## TS-890S

### Circuit update for antenna tuner failure.

## SERVICE BULLETIN ASB-0167

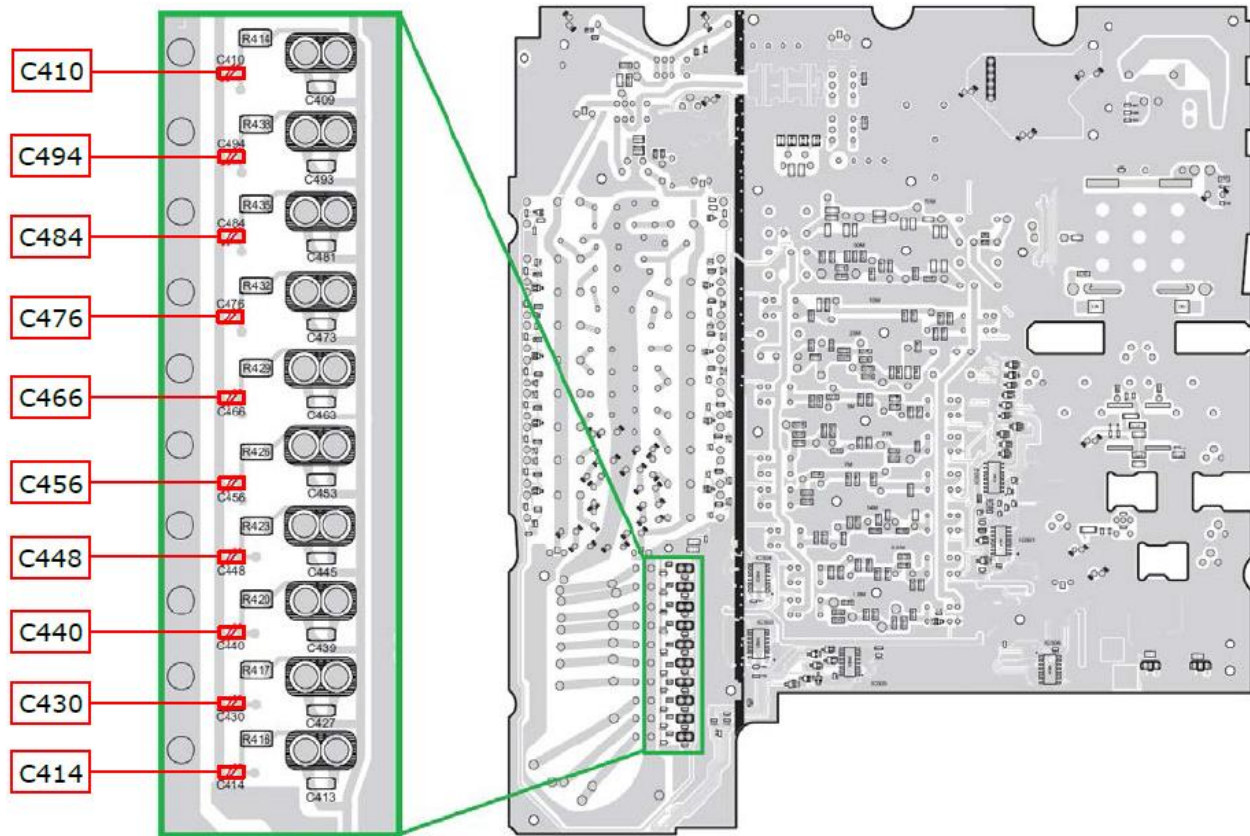
When a TS-890S Antenna Tuner circuit is repaired by replacing the relay control transistors part number DTD113ZU (mainly Q510, Q511, Q512), please also remove the chip capacitors as follows to prevent recurrence of the ATU failure.

Remove all the following 10 chip capacitors (CK73GBB1H103K) from bottom side of Final/AT unit PCB

1. Remove all power sources from TS-890 and all external connections from rear and front panels
2. Remove upper cabinet lid and RF shield to expose Final/AT Unit PCB
3. Remove Final/AT unit PCB from the chassis to expose the circuit update area on the bottom side of the PCB
4. Remove 10 small chip capacitors shown in the following picture
5. Suggest using 2 soldering irons to avoid damage to the PCB. First apply solder on both sides of each capacitor then use both soldering irons at the same time to heat the solder points of the capacitor and move it from its location
6. Caution: If the capacitor is forcibly removed and the circuit trace is torn a repair will be required or the ATU circuit will not work
7. Check area is clear of any damage and remove any solder bridges / balls
8. Re-assemble unit
9. Test ATU is operational on all bands
